ARM PrimeCell
AMBA 3 HP Matrix (PL301)
Errata Notice

This document contains all errata known at the date of issue in releases up to and including revision r1p2 of PL301 AMBA 3 HP Matrix

493515: Multiple instances connected in some mesh arrangements can deadlock**Status**

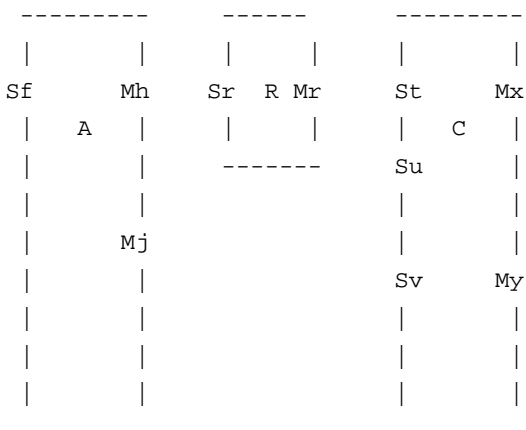
Fault status: Cat 3, Present in: r0p0-00rel0,r1p0-00rel0,r1p1-00rel0,r1p1-00rel1,r1p2-00rel0, Open.
